**GE Hitachi Nuclear Energy**

MFN 10-076

Subject: **Transmittal of ESBWR DCD Tier 2 Chapter 6 Markups Related to Engineered Safety Features**

**Transmittal of ESBWR DCD Tier 2 Chapter 6 Markups  
Related to Engineered Safety Features  
Markups and Change List**

Figure 6.2-7. TRACG Nodalization of the ESBWR Containment

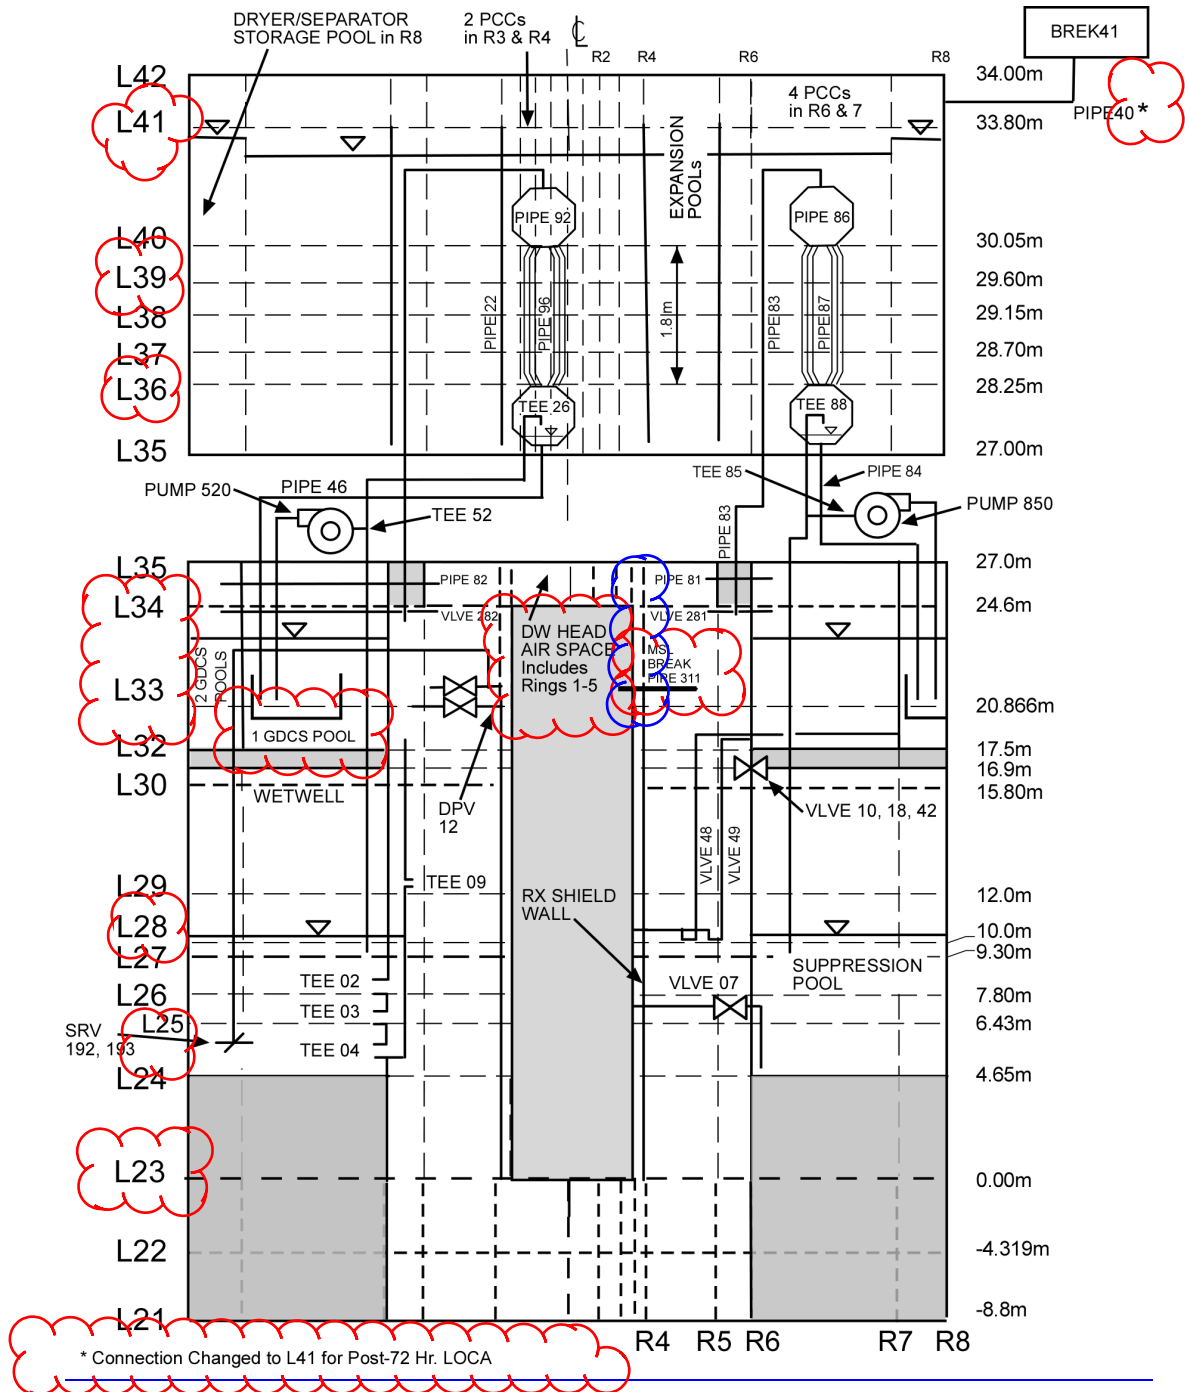
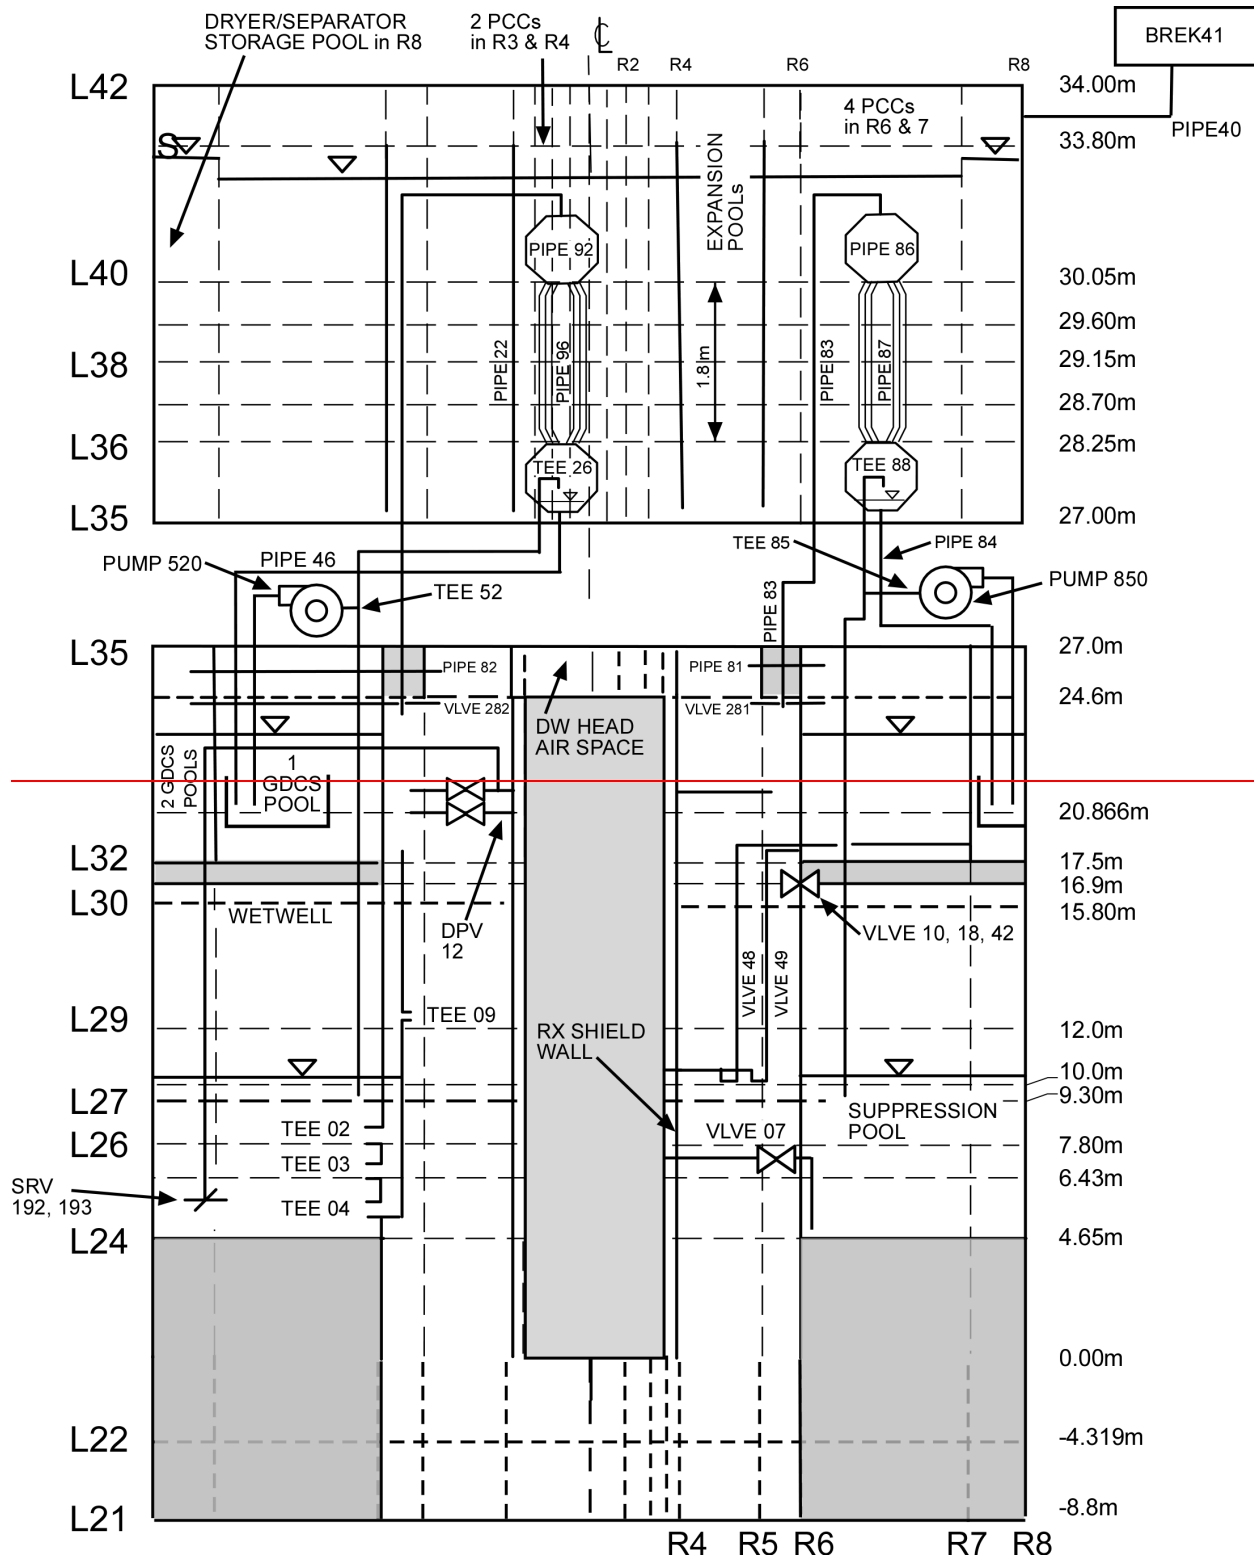
22.	F6.2-7	<p>The following corrections evolved from ACRS comments.</p> <p>a) The MSL (Main Steamline) break pipe location in the drywell is displayed correctly in the Figure (PIPE 311 connected to Level 34, Ring 5).</p> <p>b) A label is included in the Figure to indicate that the Drywell (DW) Head air space includes Rings 1 through 5.</p> <p>c) Labels for L23, L25, L28, L33, L34, L37, L39, and L41 that were missing from the Figure, have been included.</p> <p>d) An open flow area (FA) between Ring 4 and Ring 5 at Level 34, which was erroneously displayed as a solid line previously, is correctly shown as a dashed line. This open flow area allows flow from the DW Head to enter the Upper DW (without going all the way down the RPV annulus).</p> <p>e) The "1 GDCS Pool" label is correctly located in the GDCS pool (previously incorrectly located inside the PCC fan discharge tray).</p> <p>f) A footnote is added to the Figure to indicate that the connection PIPE40 to VSSL is changed to Level 41 for the post-72 hour LOCA phase. PIPE40 sets the PCCS pool overflow level, (MFN-10-076).</p>
